ELECTRICAL—CHARGING SYSTEM WARNING INDICATOR LAMP ILLUMINATED—DURING COLD AMBIENT TEMPERATURES BELOW -6 DEGREES CELSIUS (20 DEGREES F.)—VEHICLES EQUIPPED WITH 2.0L ZETEC ENGINE BUILT 7/8/2000 THROUGH 2/12/2001 ONLY

Article No. 01-5-5

FORD: 2001 ESCAPE

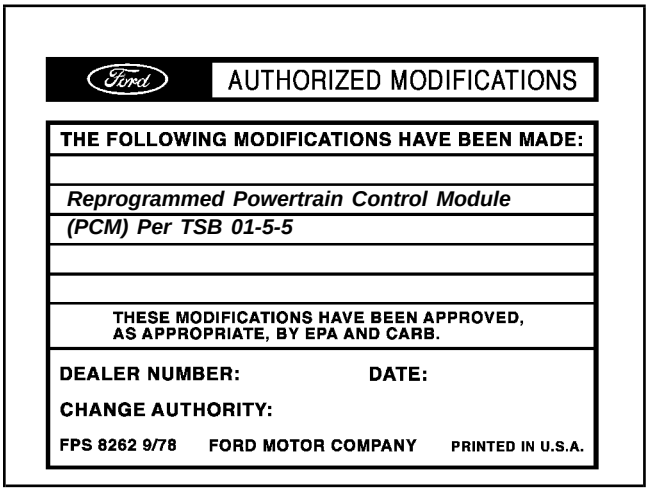
Obtain an Authorized Modifications Decal (FPS 8262 - obtainable through DOES II, 25/pkg) and list the date, dealer number, and summary of modifications performed. Select a prominent place adjacent to the Vehicle Emission Control Information Decal suitable for installing the Authorized Modifications Decal. Clean the area, install the decal, and cover it with a clear plastic decal shield.
